City Addendum No. 1 – February 26th, 2021

Re: Plymouth Ice Center – Roof Replacement Project
Plymouth Ice (PIC)
3650 Plymouth Blvd.
Plymouth, MN 55446

ARCHITECTURAL ADDENDUM NO. 1 - FEBRUARY 25, 2021

RE: Plymouth Ice Center – Roof Replacement
Plymouth Ice Center (PIC)
3650 Plymouth Blvd
Plymouth, MN 55446

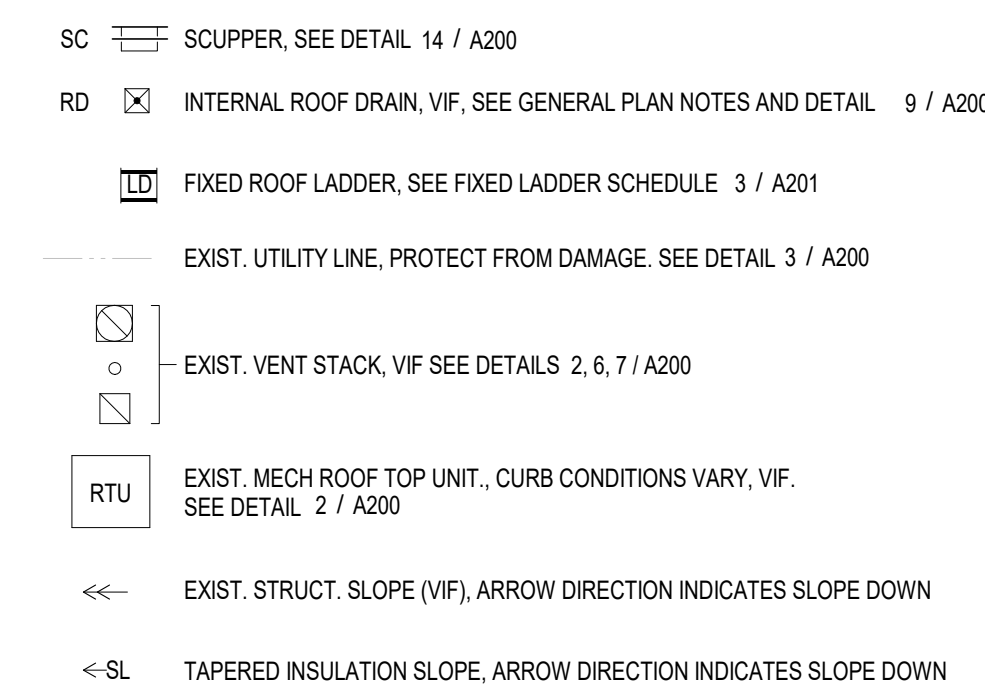
1. Revise the description and area of Alternate #1 per the following revised architectural drawing details. The approximate area of revised Alternate #1 is 27,150 SF.
2. Delete the demolition and replacement of clerestory windows (storefront assembly) from the scope of the project per the following revised architectural drawing details.

A101

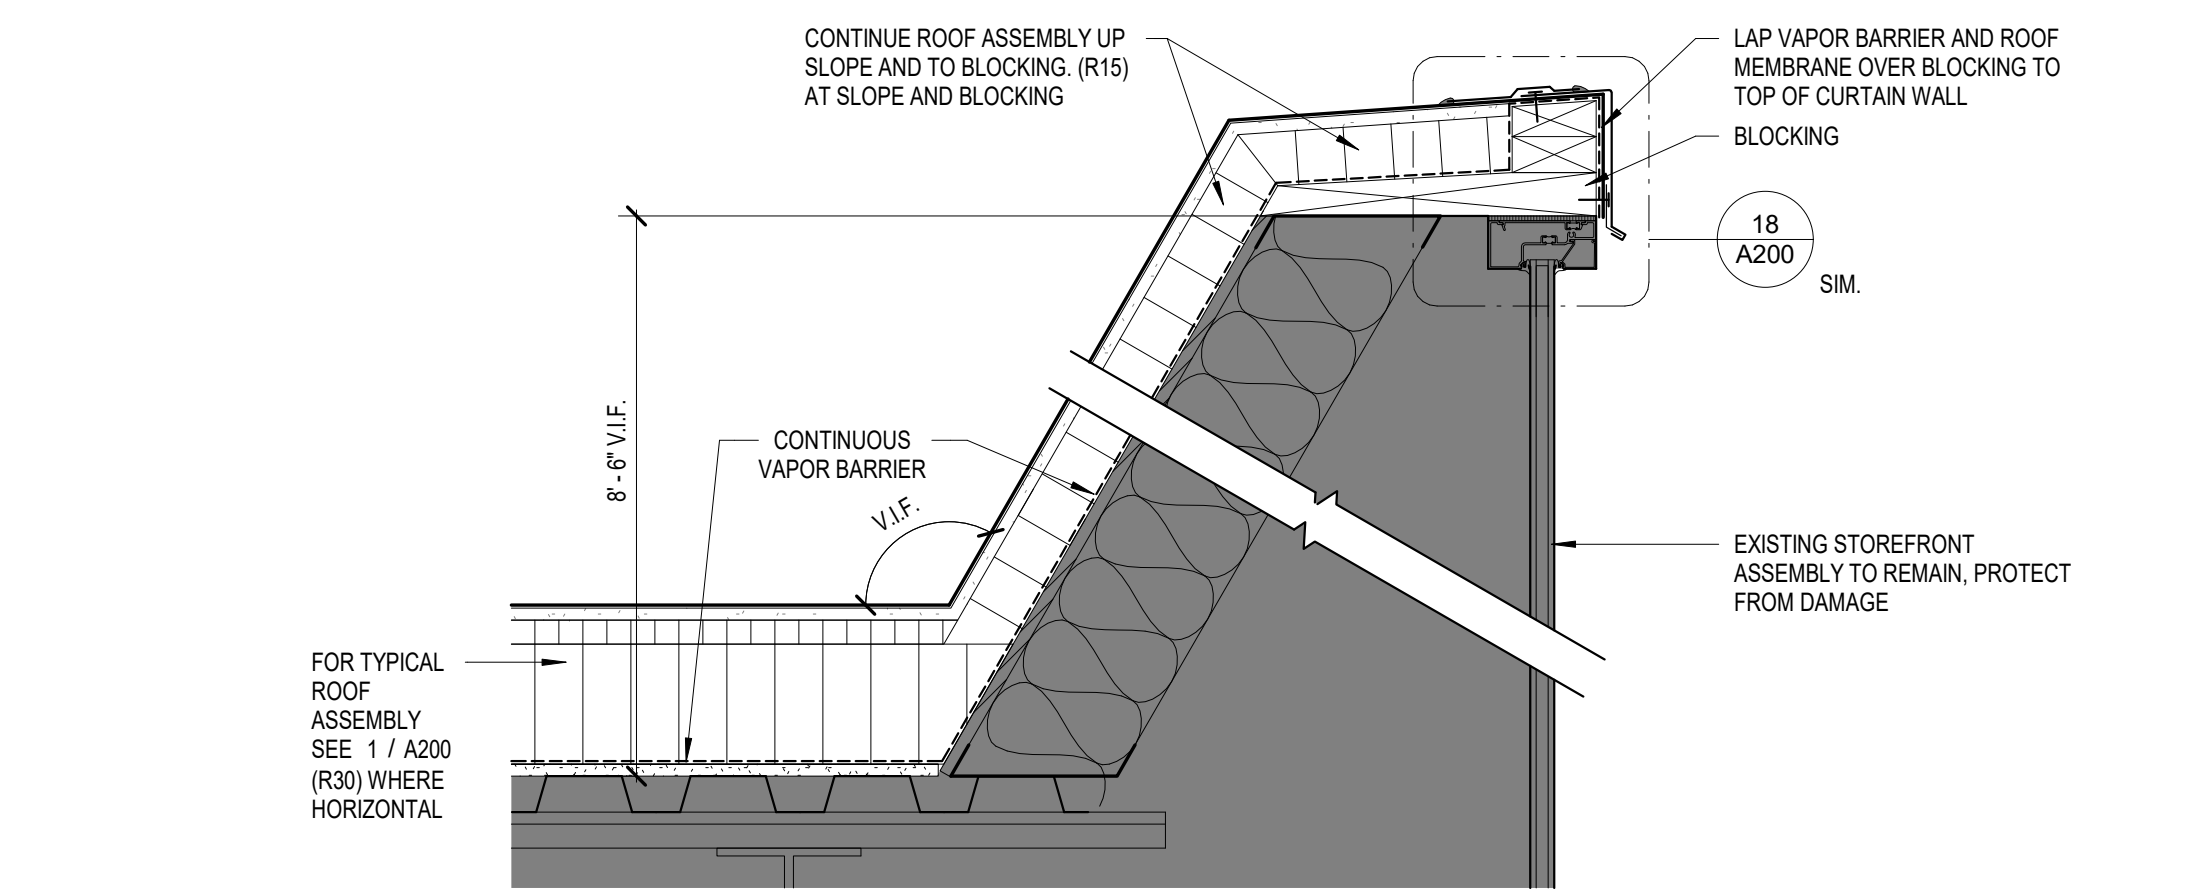
1. Revise the description of Alternate #1 under ALTERNATES located within the sheet notes per revised addendum 1 drawing detail 1/A101.
4. Revise the area of Alternate #1 shown on detail 1/A101 per revised addendum 1 drawing detail 1/A101.
